Service Campaign Bulletin

Campaign No. 2016050002, May 2016

SUBJECT: **Model 217, Model Year 2016**
Rework Right and Left Mounting Rail

Figure 2

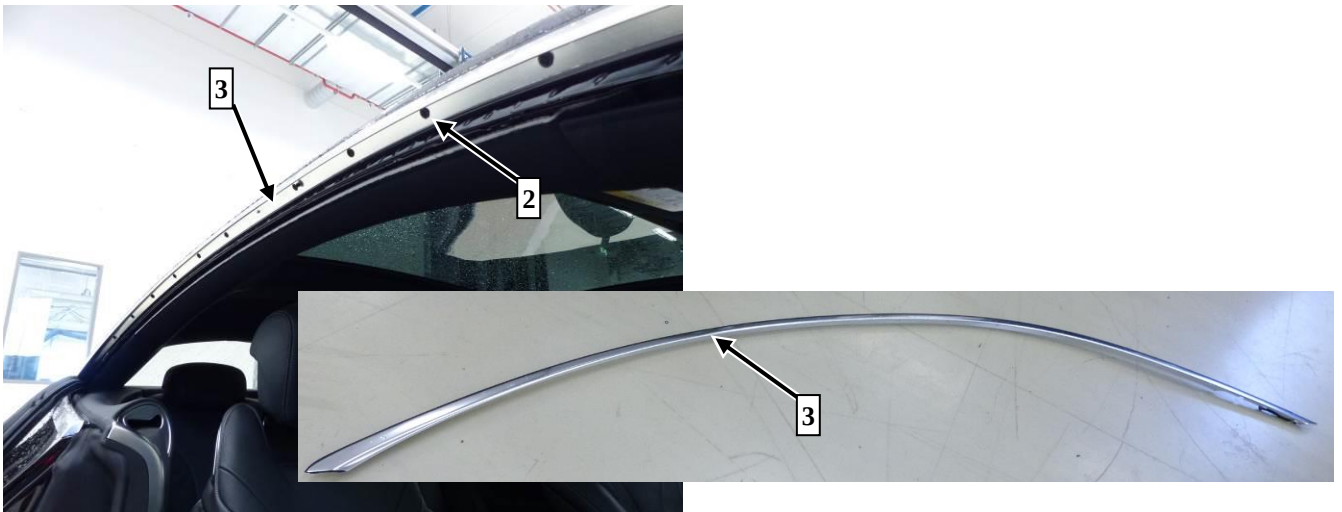
2.  Remove the mounting rail (3, Figure 2) on the driver and passenger side.
 **Note:** Release screws/bolts (2, 16 each) for disassembly.

Figure 3

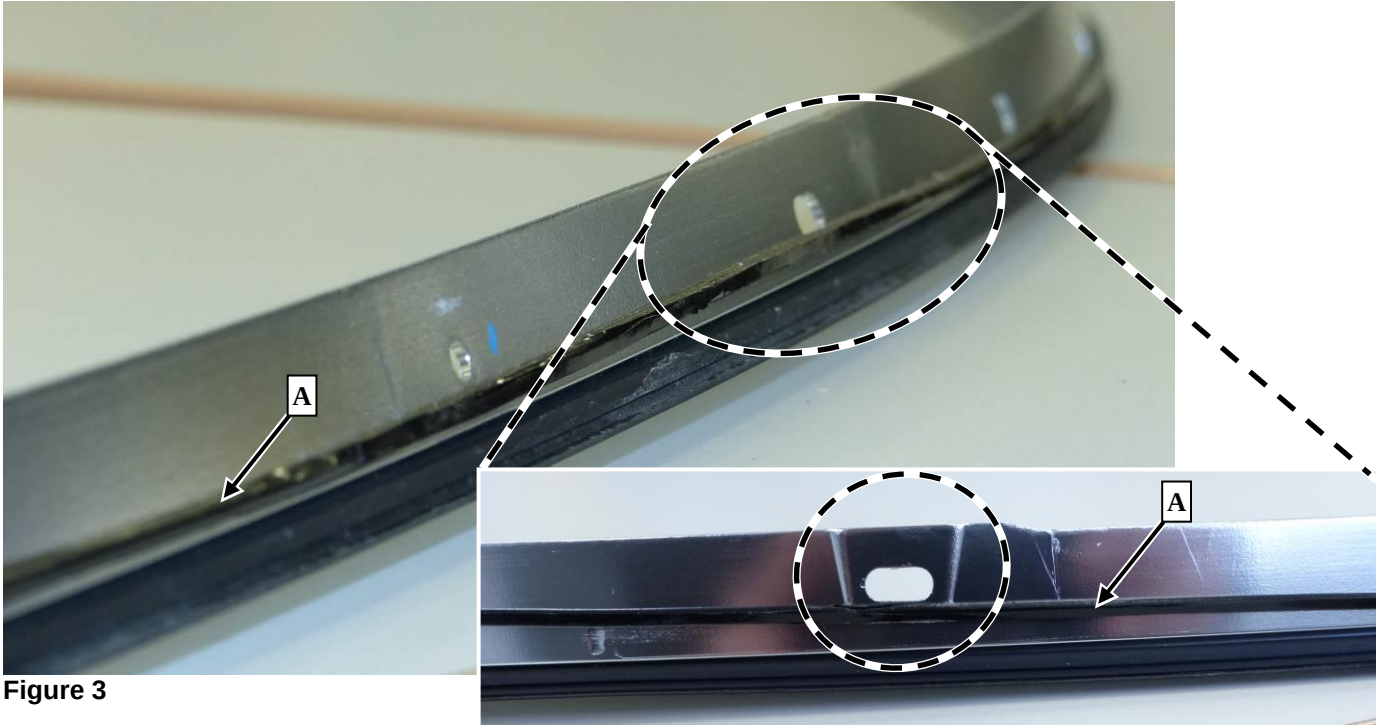
3.  Attach the butyl cord (A, Figure 3) on the upper side of the mounting:
 -  Fasten the butyl cord (A) parallel at a distance to the sealing and align it with edge of the elongated hole.
 -  Refer to Figures 4 and 5 for the position of the butyl cord (A).
